IGLU MASCOT II
13A CHURCH AVENUE,
MASCOT

Schedule of changes:

IGLU MASCOT II
13A CHURCH AVE

**General Arrangement Plan
Roof Level**

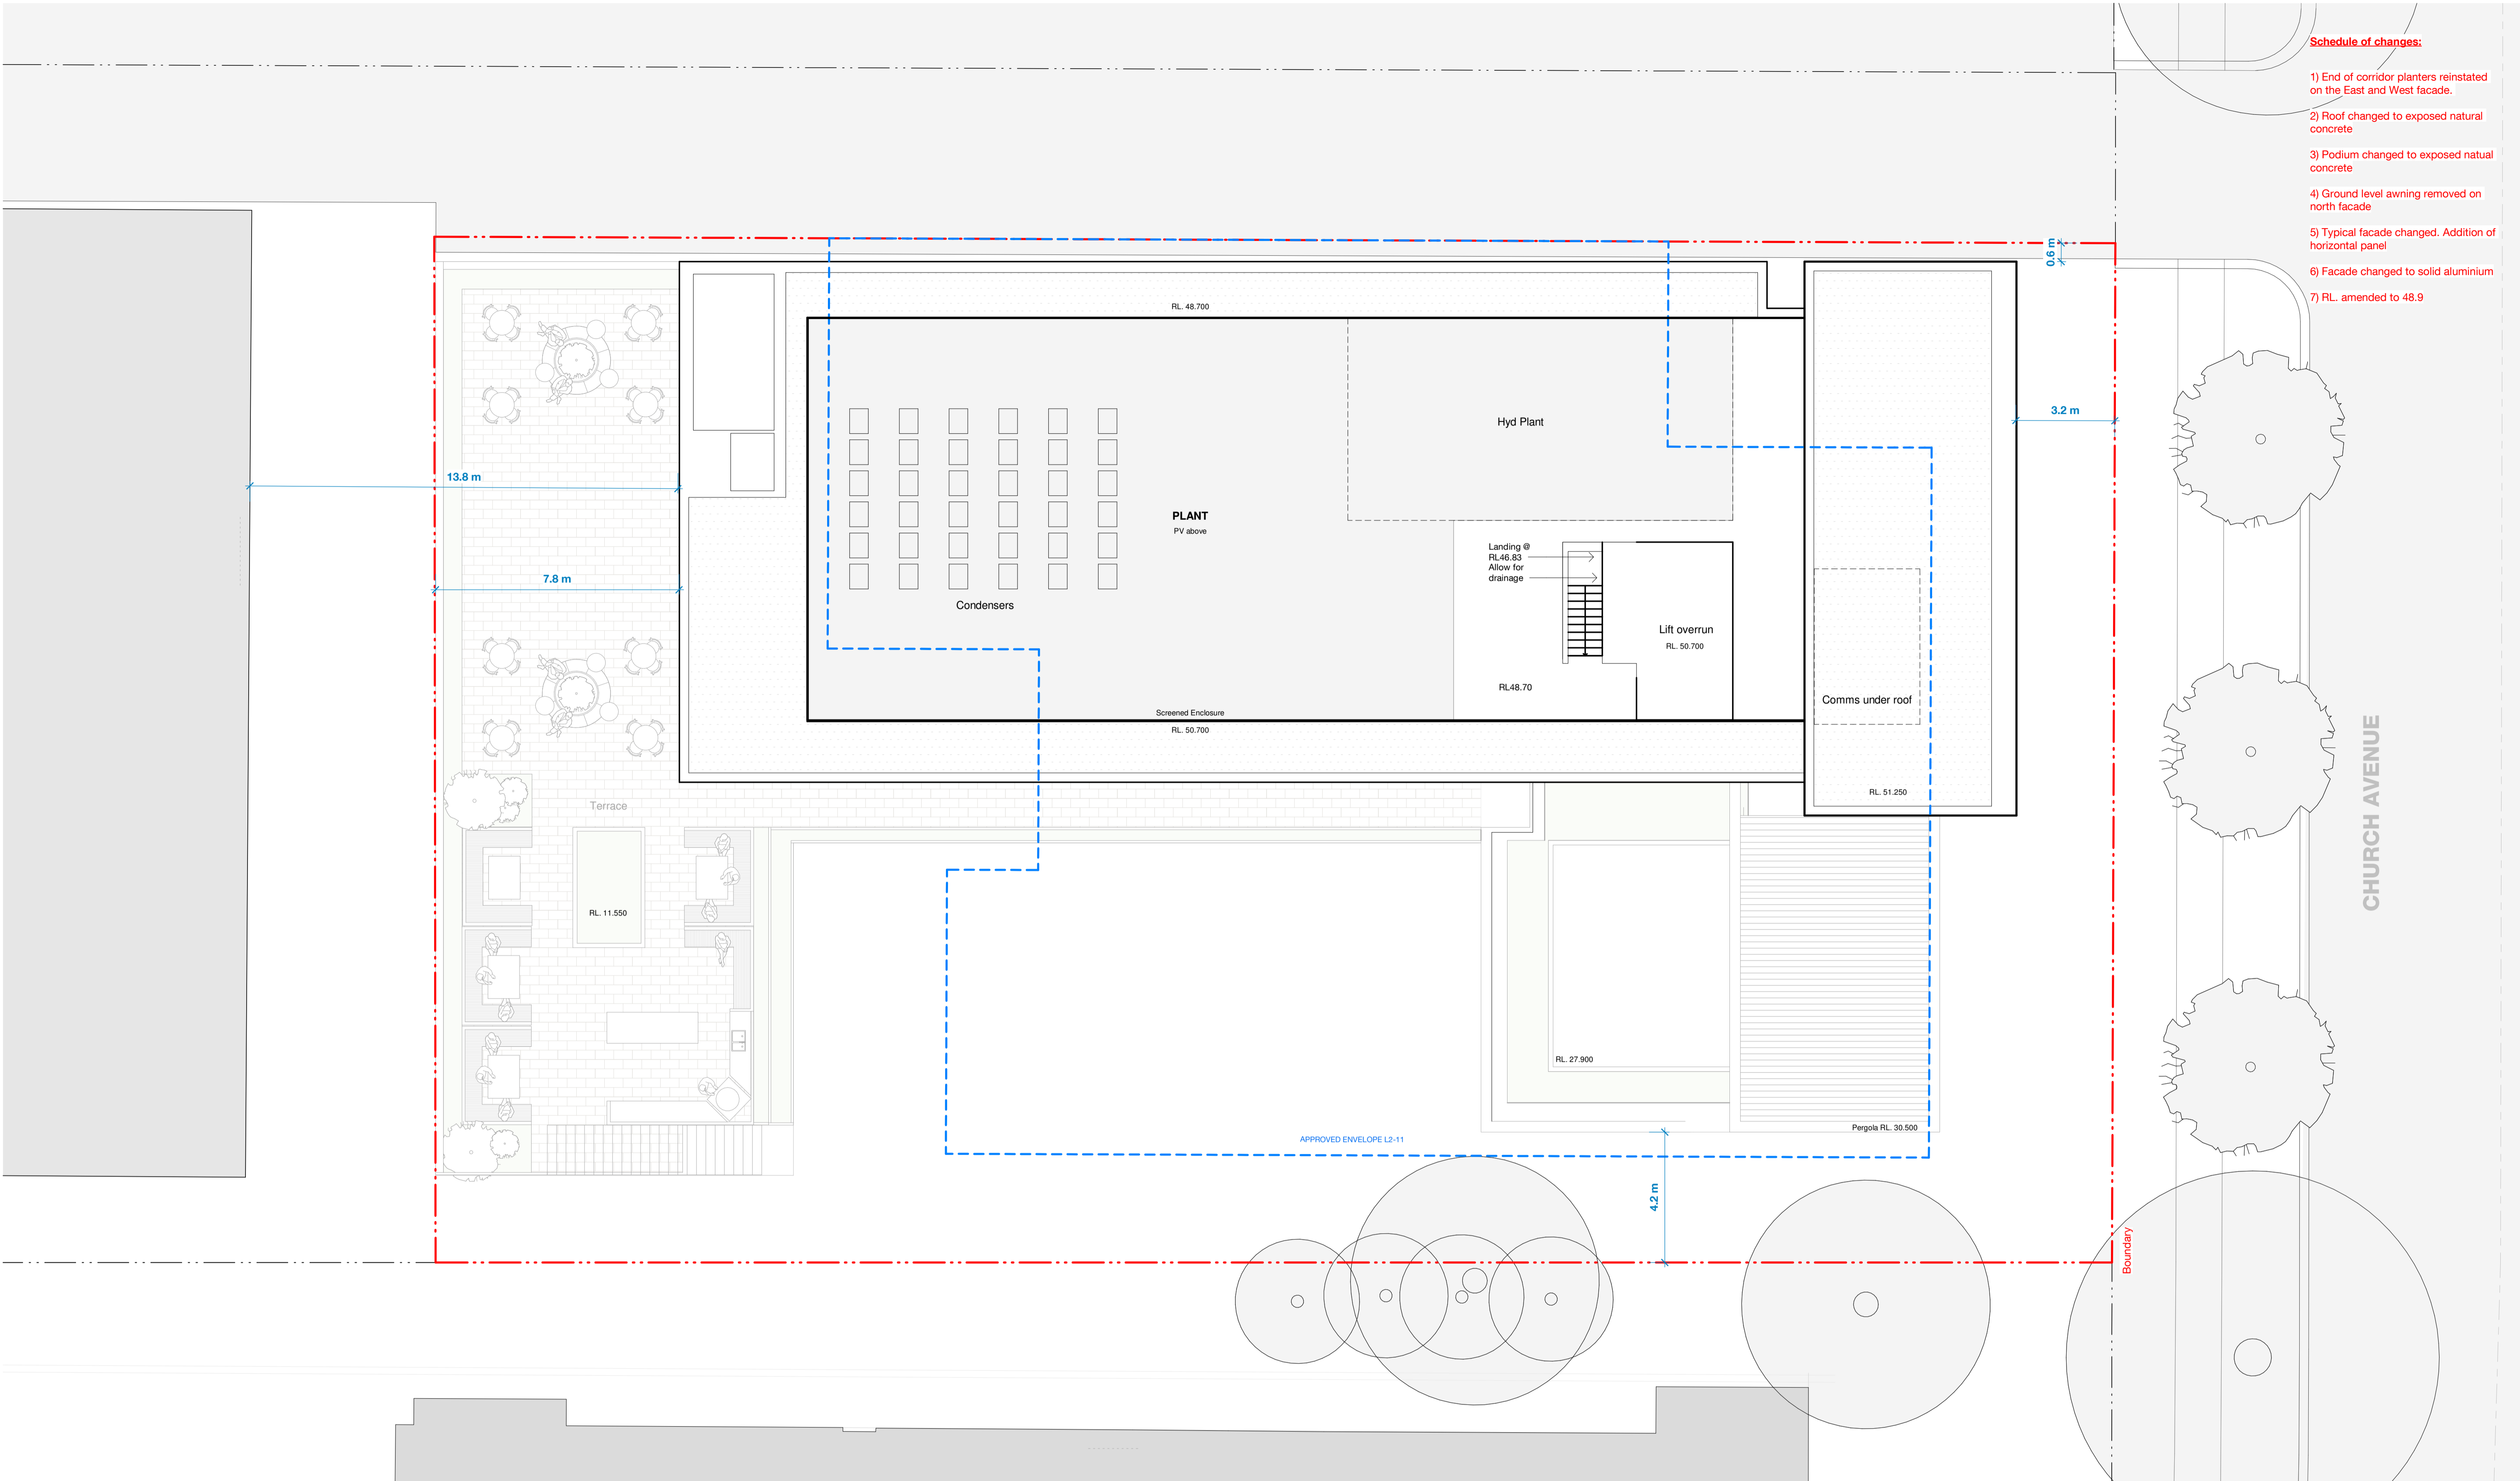
- Schedule of changes:**
- 1) End of corridor planters reinstated on the East and West facade.
 - 2) Roof changed to exposed natural concrete
 - 3) Podium changed to exposed natural concrete
 - 4) Ground level awning removed on north facade
 - 5) Typical facade changed. Addition of horizontal panel
 - 6) Facade changed to solid aluminium
 - 7) RL. amended to 48.9

Section AA

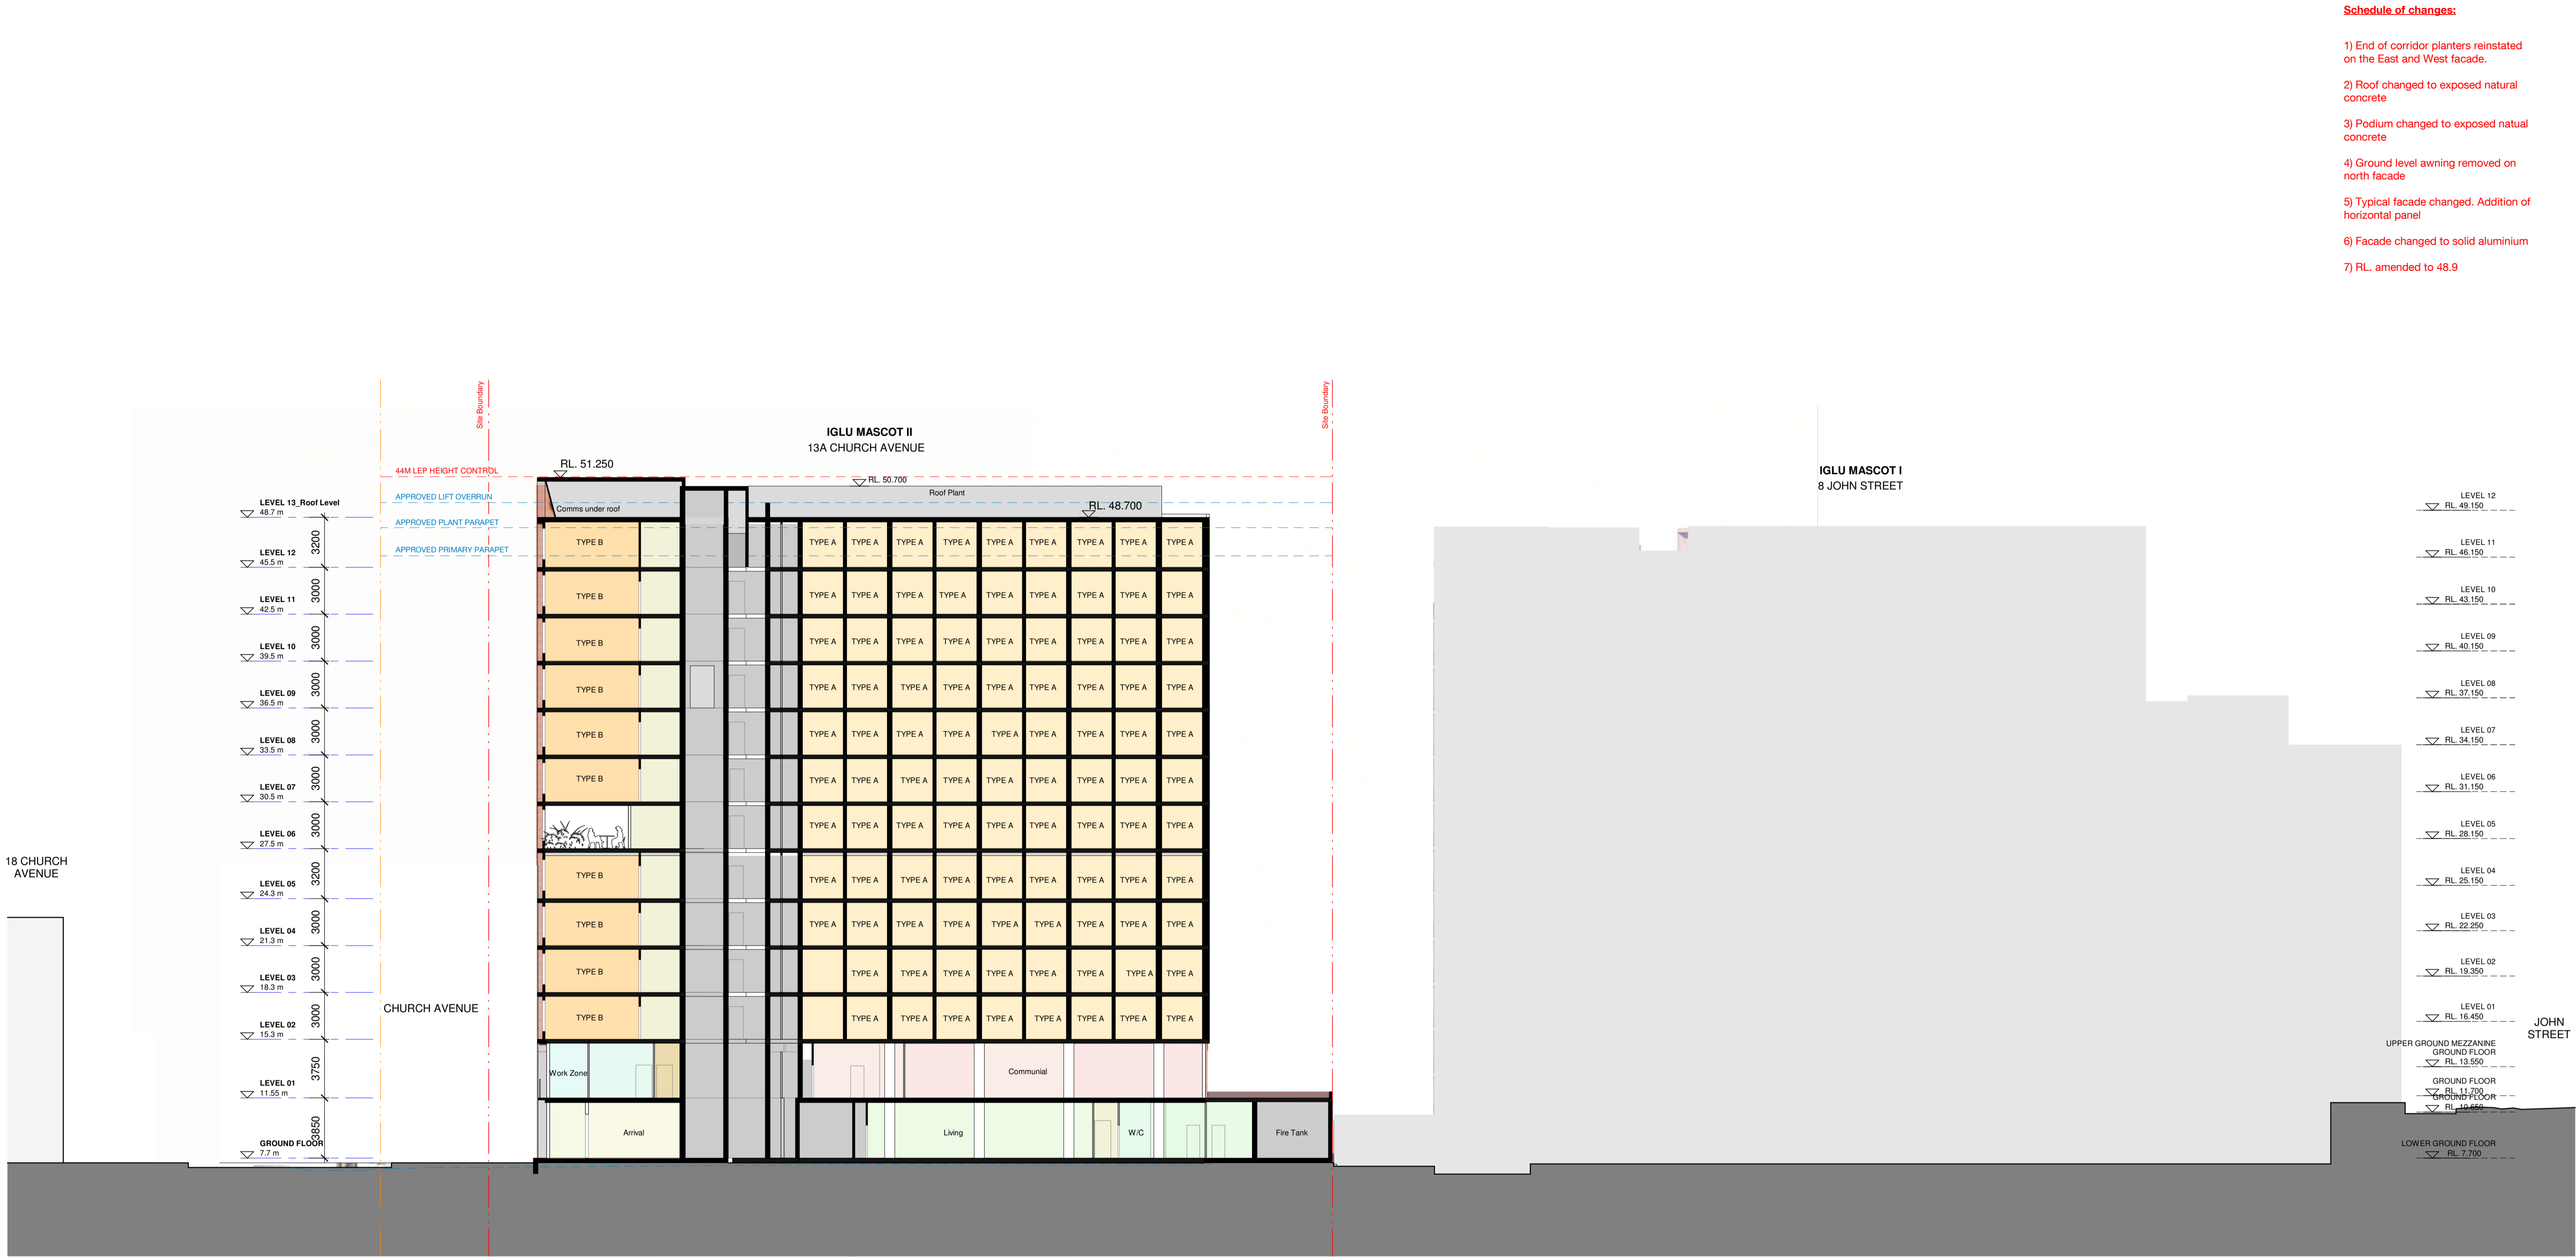
- Schedule of changes:**
- 1) End of corridor planters reinstated on the East and West facade.
 - 2) Roof changed to exposed natural concrete
 - 3) Podium changed to exposed natural concrete
 - 4) Ground level awning removed on north facade
 - 5) Typical facade changed. Addition of horizontal panel
 - 6) Facade changed to solid aluminium
 - 7) RL. amended to 48.9
